Re: Surface-water drainage — representations on applications PL_2025_10022 and PL_2026_03223

Site: Land at Witt Road, Winterslow, Wiltshire

PL_2026_03223 — Drainage Flow Path & Downstream Surface-Water Flood Risk

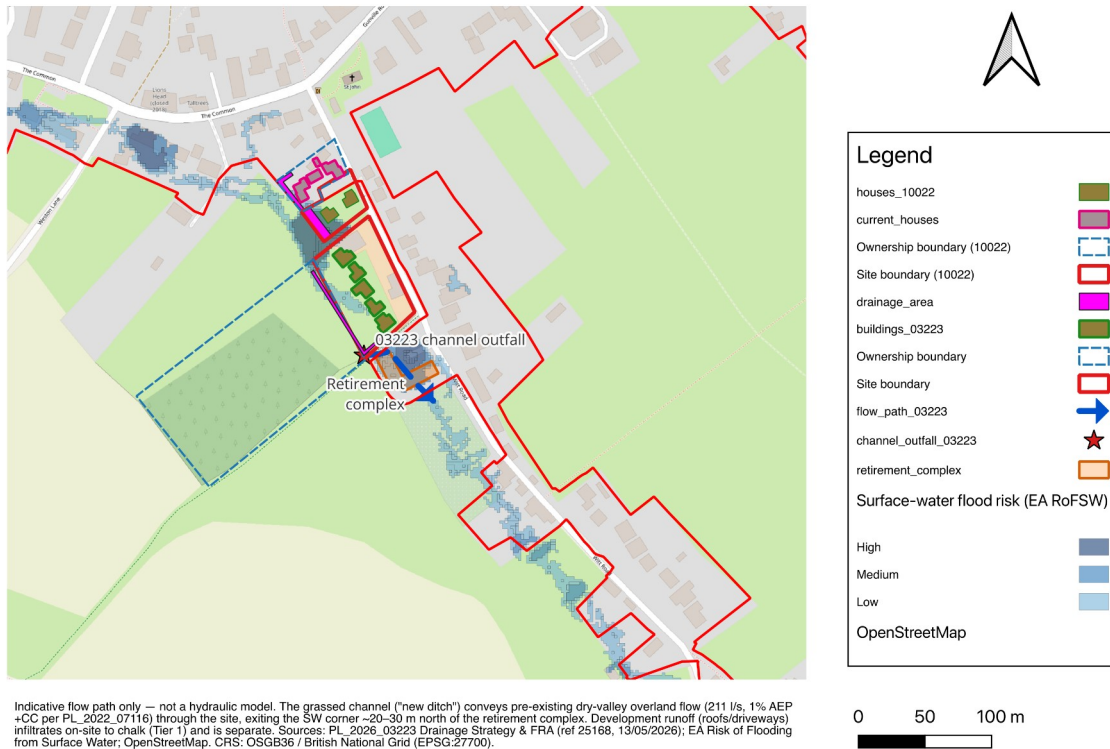
The 03223 channel outfall lies at the south-west corner of that site (approximately NGR 424748, 132440), only some 20–30 m north of the retirement complex on Witt Road. The Environment Agency’s Risk of Flooding from Surface Water mapping shows a High-risk band reaching the outfall and the northern edge of that complex.

The applicant’s own Strategy (para 10.1) states only that the channel “mimics the existing run-off regime” — in other words, that it does not increase downstream flow, not that water does not leave the site. Concentrating and routing roughly 211 l/s to a single outfall immediately upstream of an occupied and potentially vulnerable site that is already in a High surface-water flood-risk zone warrants explicit assessment of the receiving ground and of the onward overland route. I do not consider “mimics existing” to be a sufficient answer where the receptor is this sensitive.

To assist, I enclose an indicative plan I have prepared (overleaf) showing the 03223 channel outfall, an indicative flow path, and the Environment Agency surface-water flood-risk bands in relation to the retirement complex. For the avoidance of doubt, I am a lay resident; the figures quoted above are taken from the applicants' own drainage documents and from Environment Agency flood mapping, and the enclosed plan is indicative only and not a hydraulic model.

1. assess the three related schemes cumulatively, as one hydraulic system, rather than in isolation;
2. require a defined, connected surface-water flow path across the sites, with exceedance flows (beyond the 1% AEP design event) routed and demonstrated to, and beyond, the retirement complex;
3. require verified infiltration testing for each soakaway, and re-validation of the design against the current Environment Agency climate-change allowances;
4. secure long-term ownership, maintenance and adoption responsibility for the conveyance channel/ditch by condition or agreement; and
5. if these matters cannot be satisfied, recommend refusal, or that determination be deferred pending a cumulative drainage assessment.
